City of Tualatin

NOTICE OF DECISION

**ARCHITECTURAL REVIEW FINDINGS AND
DECISION**
**** APPROVAL WITH CONDITIONS ****

Case #:	AR-16-0001
Project:	Koch Corporate Center, Buildings 10, 11, 12
Location:	20600 SW 115th Avenue (Tax Lot 2S1 27AC 00700)
Applicant/Owner:	Pacific Realty Associates, LP
Applicant/Rep.:	Mark Person, Mackenzie, Portland, OR, 503.224.9560

KEYNOTES

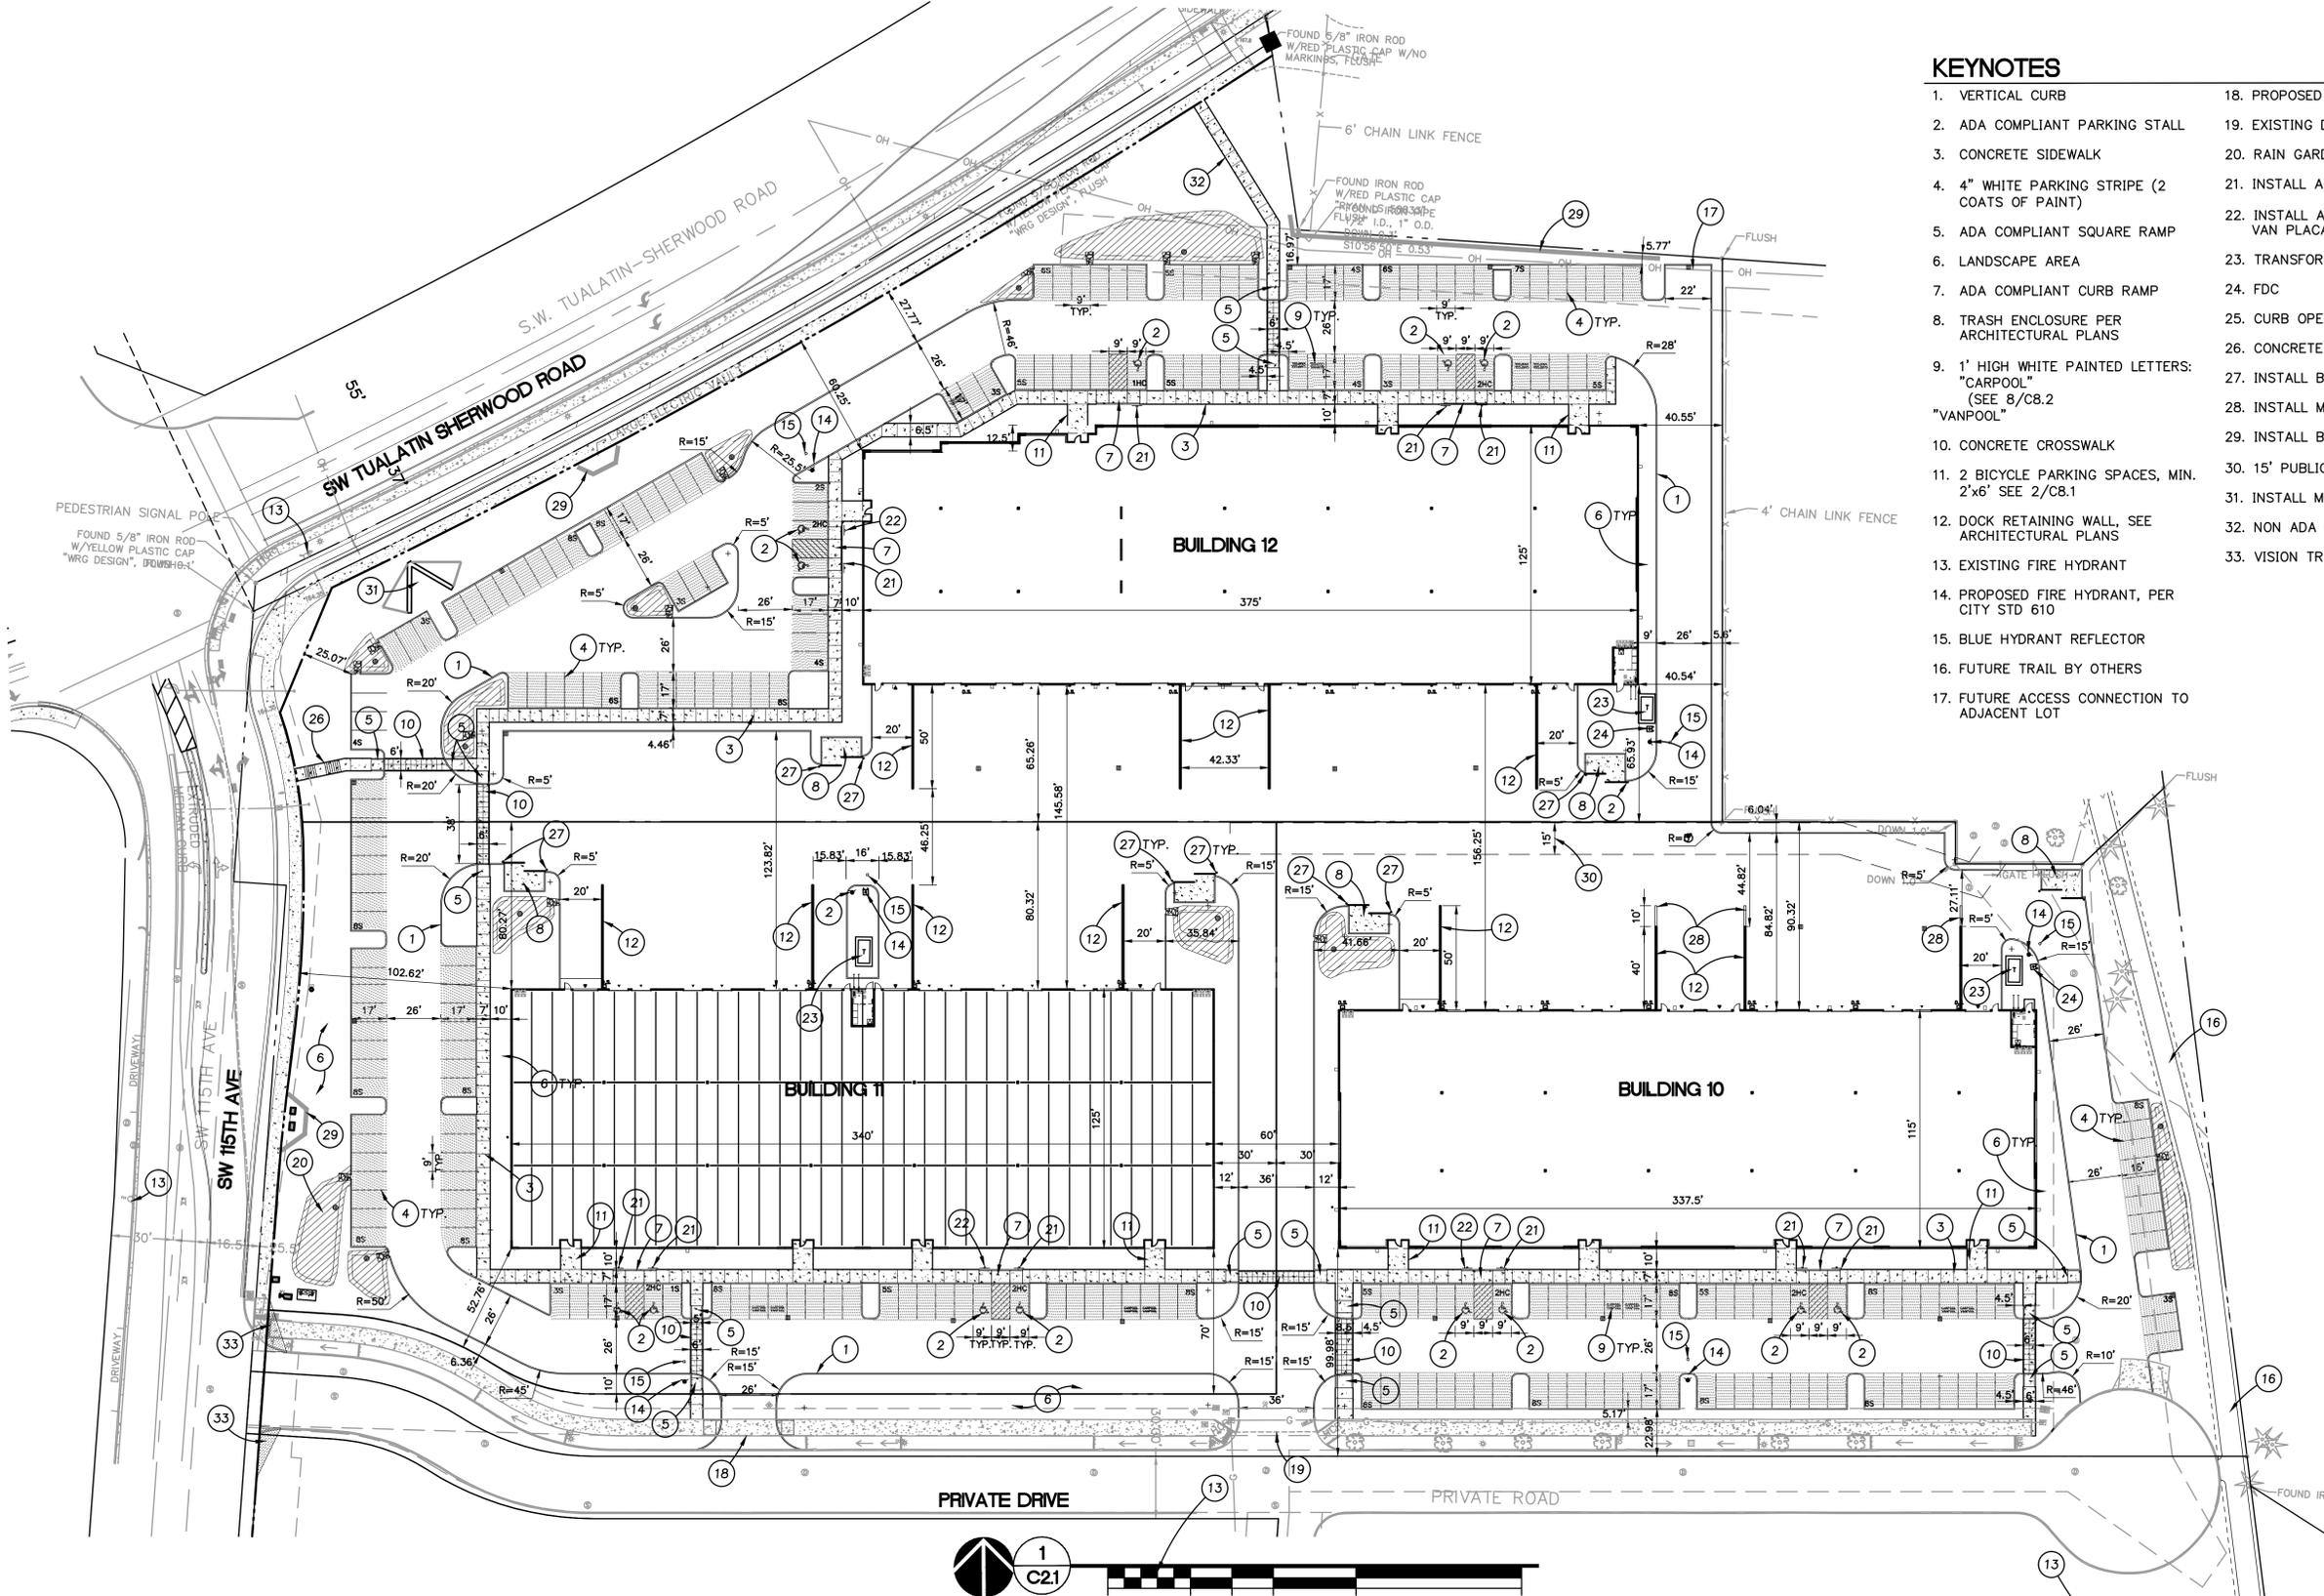
Staff notes that there is also an accommodation for future connection to the adjacent site to the north, see keynote 17 on sheet C2.1.

Staff notes that references to buildings 1, 5 and 8 are incorrect. The proposed buildings shown on sheet C2.1 are numbered 10, 11 and 12.

Staff finds that the transformers shown on sheet C2.1 are not shown on the landscape plans; please see discussion in TDC 73.160(4)(a) below.

Staff finds that the transformers shown on sheet C2.1 are not shown on the landscape plans and it is therefore not possible to determine whether or not the proposed landscaping provides adequate screening of the on-grade equipment.

Staff finds that while the applicant has included proposed bicycle parking in the site data tables on sheet C2.1, this information is not illustrated on the site plan. Bicycle parking facilities shall either be lockable enclosures in which the bicycle is stored, or secure stationary racks, which accommodate a bicyclist's lock securing the frame and both wheels. Each bicycle parking space shall be at least 6 feet long and 2 feet wide, and overhead clearance in covered areas shall be at least 7 feet, unless a lower height is approved through the Architectural Review process. Bicycle parking areas and facilities shall be identified with appropriate signing as specified in the Manual on Uniform Traffic Control Devices (MUTCD) (latest edition). At a minimum, bicycle parking signs shall be located at the main entrance and at the location of the bicycle parking facilities.

SHEET TITLE:
GRADING PLAN

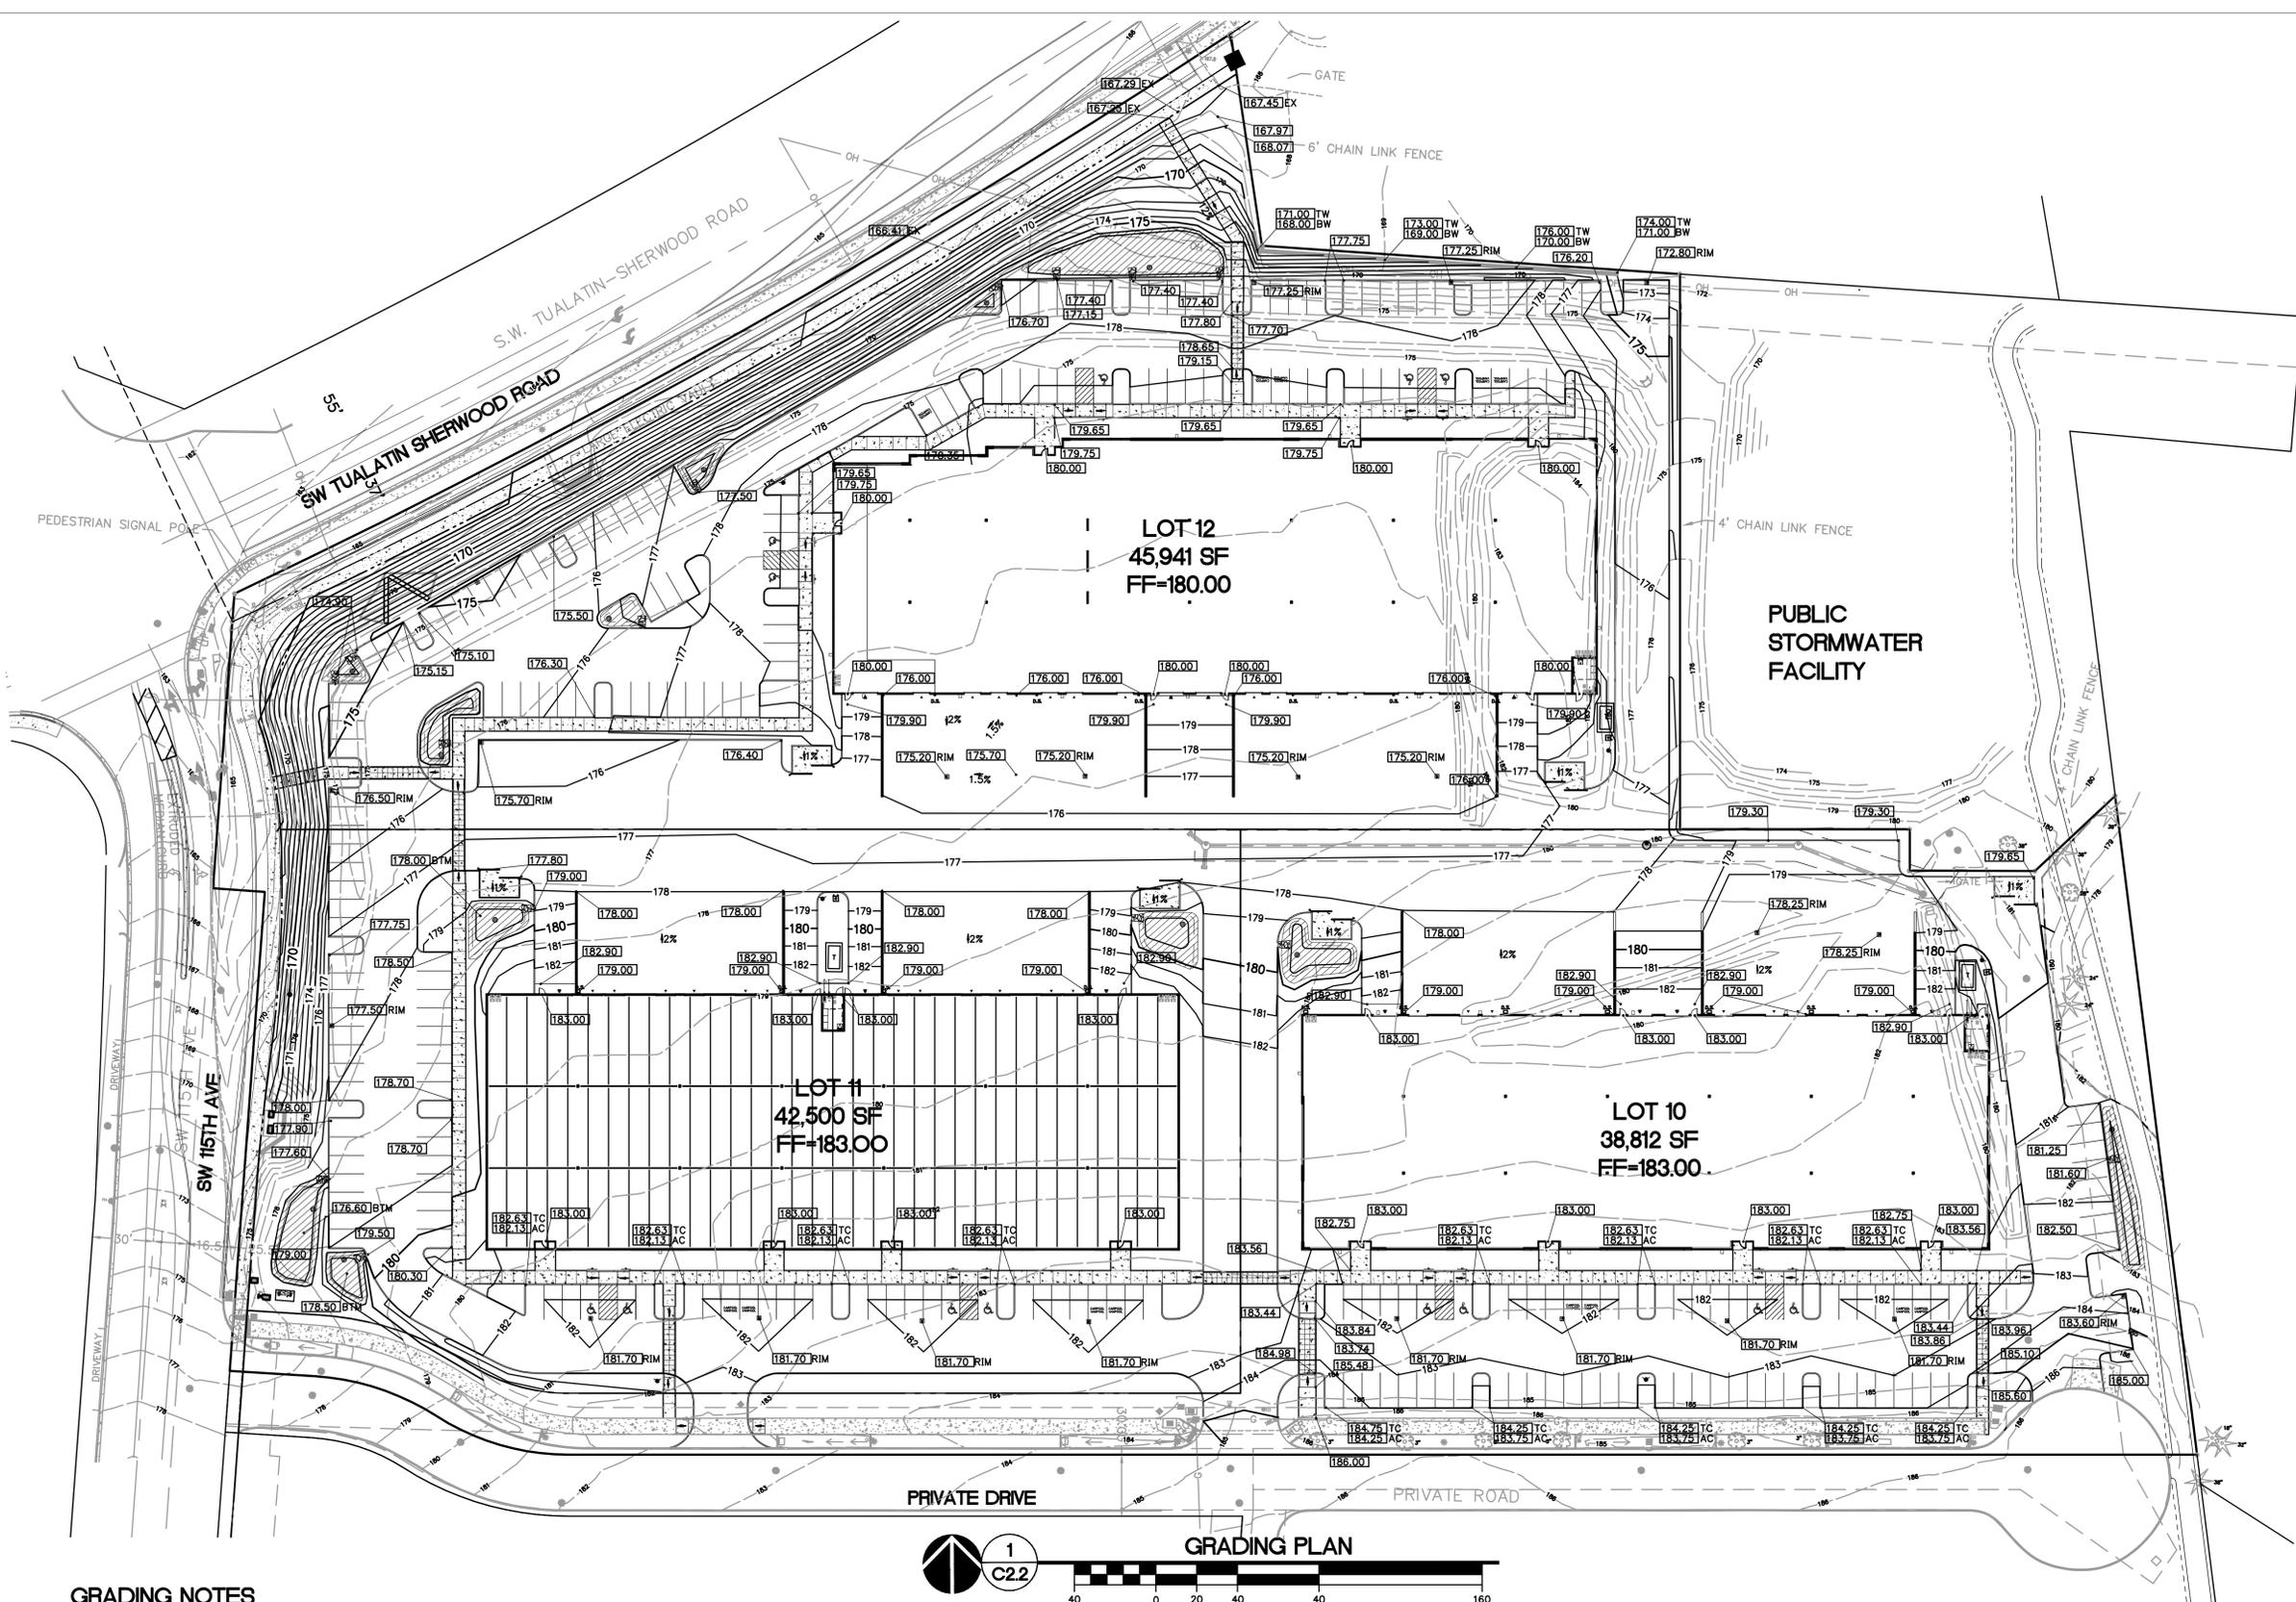
AR-11 The Applicant shall revise the grading plan (sheet C2.2) to graphically illustrate and note that the trees in the far eastern portion of the project site will be preserved and protected during the construction process. TDC 73.250(2)

Staff finds that the slope of the accessway to SW Tualatin-Sherwood Road is steeper than what is generally recommended for bicycle ramps. Sheet C2.2 indicates the slope of the proposed accessway to be 12 percent. Slopes over 5 percent are not recommended, but staff concedes that the topography of this site may necessitate a steeper slope. In addition, there are other bicycle access points from the private drive south of the project site via SW 115th Avenue.

Condition of Approval: *The applicant shall revise the grading plan (sheet C2.2) to graphically illustrate and note that the trees in the far eastern portion of the project site will be preserved and protected during the construction process pursuant to TDC 73.250(2).*
